## RECALL 25V005 / 2025-008 REMEDY INSTRUCTIONS

CERTAIN 2025 – SHASTA OASIS: SST31QB, SST525BHS, SST526BH, SST526DB, SST526RBS, SST530QB & SST532BEDS  
 CERTAIN 2025 – SPIRIT: SBT5260BH, SBT5250BHS, SBT5210CK, SBT5320BEDS, SBT5260RBS & SBT310QB

**GAS LINE INSPECTION AND REPLACEMENT  
FOR FRONT BURNER**

**MODELS:  
Three Burner  
410-2030**

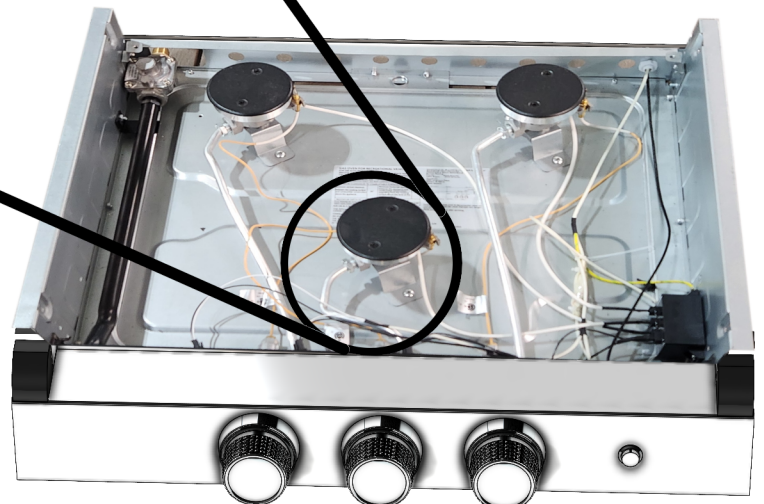
6. With a small brush, apply the soapy water to the areas indicated in the image to the left.

8. Visually inspect the areas for any bubbles forming which indicates a leak.

9. If no leaks are detected, record the serial number and re-assemble the unit; If a leak is detected move on to the next steps to replace the faulty gas line with a new one.

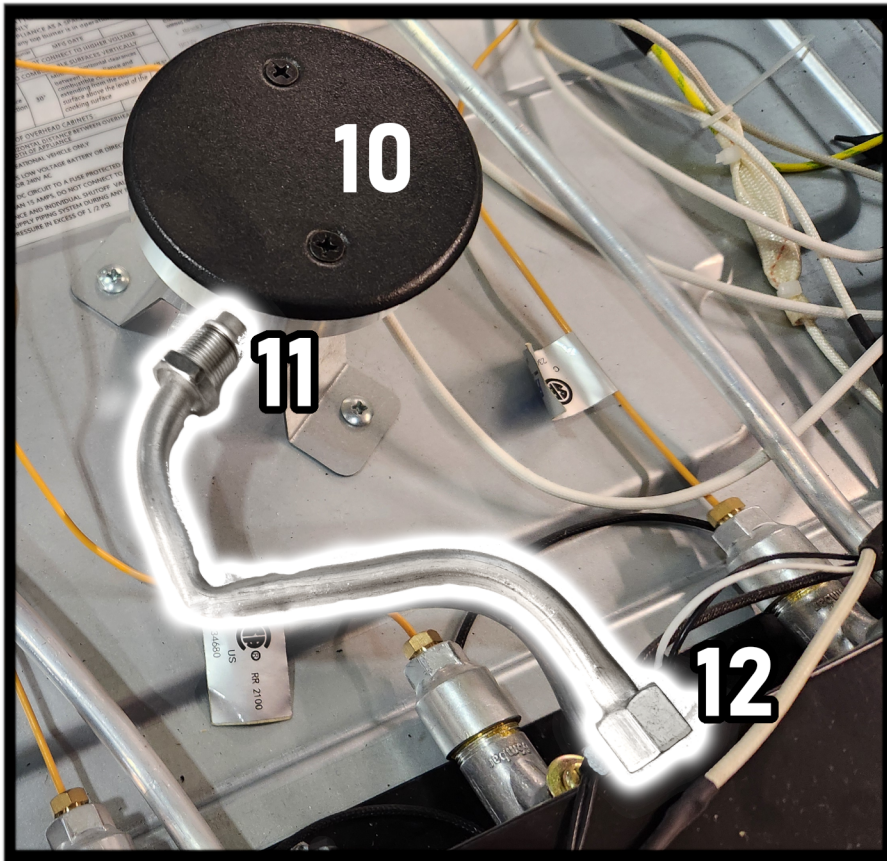
10. Brace burner with one hand so its position isn't altered .

11. With a 14mm wrench carefully turn the connector counter-clockwise.

12. With a 16mm wrench carefully turn the connector counter-clockwise.

13. Follow the procedure in reverse to install new gas line and reassemble cooktop.
